PSE IRP Feedback Report

Webinar 11: Flexibility analysis & Portfolio draft results

December 15, 2020

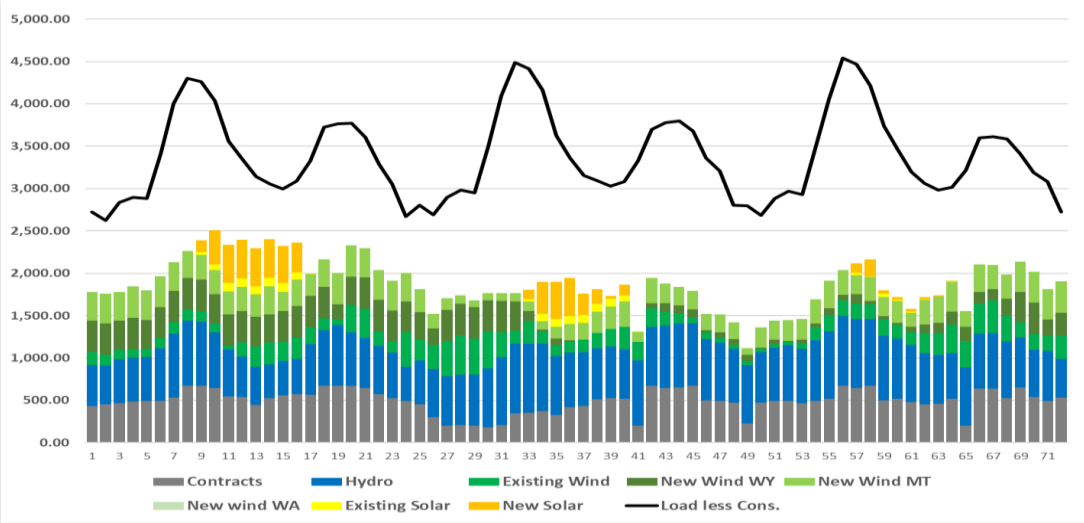
Feedb ack Form Date	Stakeho lder	Comment	PSE Response								
12/21/ 2020	Katie Ware, Renewa ble Northwe st	Flexibility Analysis: [paraphrased by PSE, see attachment for original submittal] Renewable Northwest encourages PSE to provide a flexibility value of the ‘diversity savings’ from participation in the Energy Imbalance Market.	The EIM market is incorporated into the real time, fifteen-minute dispatch. The flexibility benefit then takes the change in dispatch from the day ahead and hourly dispatch to the real time dispatch and therefore the EIM benefits are incorporated into the flexibility benefit.								
12/21/ 2020	Katie Ware, Renewa ble Northwe st	Portfolio Draft Results: [paraphrased by PSE, see attachment for original submittal] Renewable Northwest suggests that ELCC values for storage resources should be higher than described in the presentation, particularly pumped hydro storage.	<p>Thank you for you feedback and concern for the ELCC analysis. In the draft 2021 IRP, Chapter 7, Resource Adequacy Analysis, PSE describes the analysis around energy storage ELCC.</p> <p>Below is an excerpt from Chapter 7, page 7-31:</p> <p><b>STORAGE CAPACITY CREDIT.</b> The estimated peak contribution of two types of batteries were modelled in RAM as well as pumped hydro storage. The lithium-ion and flow batteries modeled can be charged or discharged at a maximum of 100 MW per hour up to two, four or six hours duration when the battery is fully charged. For example, a four-hour duration, 100 MW battery can produce 400 MWh of energy continuously over four hours. Thus, the battery is energy limited. The battery can be charged up to its maximum charge rate per hour only when there are no system outages. The battery can be discharged up to its maximum discharge rate or just the amount of system outage (adjusted for its round-trip [RT] efficiency rating) as long as there is a system outage and the battery is not empty.</p> <p>As stated previously, the LOLP is not able to distinguish the impacts of storage resources on system outages since it counts only draws with any outage event but not the magnitude, duration and frequency of events within each draw. Because of this, the capacity credit of batteries was estimated using expected unserved energy (EUE). The analysis starts from a portfolio of resources that achieves a 5 percent LOLP, then the EUE from that portfolio is calculated. Each of the storage resources is then added to the portfolio, which leads to lower EUE. The amount of perfect capacity taken out of the portfolio to achieve the EUE at 5 percent LOLP divided by the peak capacity of the storage resource added determines the peak capacity credit or ELCC of the storage resource. The estimated peak contribution of the storage resources is shown in Figure 7-19. The low peak capacity contribution for energy is because these are short duration resources. As shown in figures 7-8 and 7-12 above, loss of load events can have extended durations of 24 hours or more. Since energy storage resources have a short discharge period, they have little to contribute during extended duration events.</p> <p><i>Figure 7-19: Peak Capacity Credit for Battery Storage Based on EUE at 5% LOLP</i></p> <table><tr><th>BATTERY STORAGE</th><th>Capacity (MW)</th><th>2021 IRP Year 2027</th><th>2021 IRP Year 2031</th></tr><tr><td>Lithium-ion, 2 hr, 82% RT efficiency</td><td>100</td><td>12.4%</td><td>15.8%</td></tr></table>	BATTERY STORAGE	Capacity (MW)	2021 IRP Year 2027	2021 IRP Year 2031	Lithium-ion, 2 hr, 82% RT efficiency	100	12.4%	15.8%
BATTERY STORAGE	Capacity (MW)	2021 IRP Year 2027	2021 IRP Year 2031								
Lithium-ion, 2 hr, 82% RT efficiency	100	12.4%	15.8%

Feedb ack Form Date	Stakeho lder	Comment	PSE Response			
			Lithium-lin, 4 hr, 87% RT efficiency	100	24.8%	29.8%
			Flow, 4 hr, 73% RT efficiency	100	22.2%	27.4%
			Flow, 6 hr, 73% RT efficiency	100	29.8%	35.6%
			Pumped Storage, 8 hr, 80% RT efficiency	100	37.2%	43.8%
			<p>The below is an excerpt from Chapter 3, page 3-25:</p> <p>Figure 3-14 is a 12x24 table that shows the loss of load hours prior to the addition of new resources. The plot represents a relative heat map of the number hours of lost load summed by month and hour of day. The majority of the lost load hours still occur in the winter months. From this chart, the large blocks of yellow, orange, and red in January and February illustrate long duration periods, 24 hours or more, with a loss of load event. The portfolio optimization model must meet these long duration capacity shortfall events using generic resources. Given current technologies, energy storage and demand response do not completely meet the peak capacity needs because of their short duration of availability.</p>

Feedb ack Form Date	Stakeho lder	Comment	PSE Response																																	
			<div>December peak Bundle 10: Mid vs 6 year ramp</div>

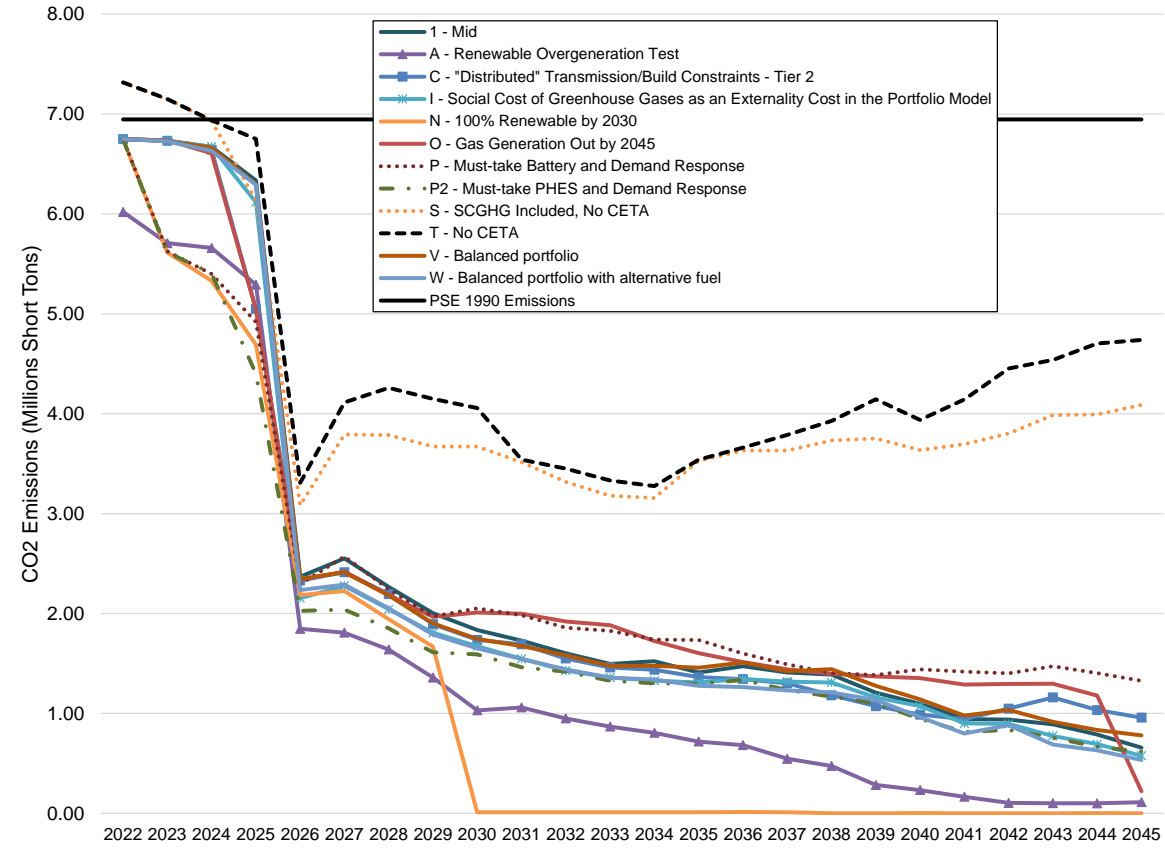
12/28/ 2020	Kyle Frankiewich, Washington	Slides 13 & 14 – Slide 13 shows the amount of renewables PSE forecast it would need to acquire in without DERs, including EE and DR. Slide 14 shows the amount of renewables PSE estimates it would need to acquire under its medium scenario with cost-effective DERs. They do not provide the NPV or Levelized Cost of	<p>Chapter 3 of the draft 2021 IRP addresses the decisions behind the draft preferred portfolio and includes a comparison of costs and builds to the Mid portfolio.</p> <p>PSE will also reach out to the WUTC to clarify our understanding of the question.</p>

<p>NOTE: The 2-year pro-rata share savings are obtained by dividing the 10-year savings by 5.</p> <p>The 6-year ramp sensitivity results will be available with the final IRP. When compared to the Mid Scenario, the 6-year ramp will likely result in a higher 2-year number but the 2-year pro-rata share number will not change, since it's the same 10-year savings being implemented at a faster pace over 6 years. From a peak contribution perspective the 6-year ramp does provide peak savings at a faster pace as well.</p>	Compare 2021 IRP to 2020-21 Program Targets	2 year	2 year pro-rata share	Mid Scenario Cost Effective EE, aMW	42.37	54.59	Current 2020-2021 Targets	NA	54.40
Compare 2021 IRP to 2020-21 Program Targets	2 year	2 year pro-rata share										
Mid Scenario Cost Effective EE, aMW	42.37	54.59										
Current 2020-2021 Targets	NA	54.40
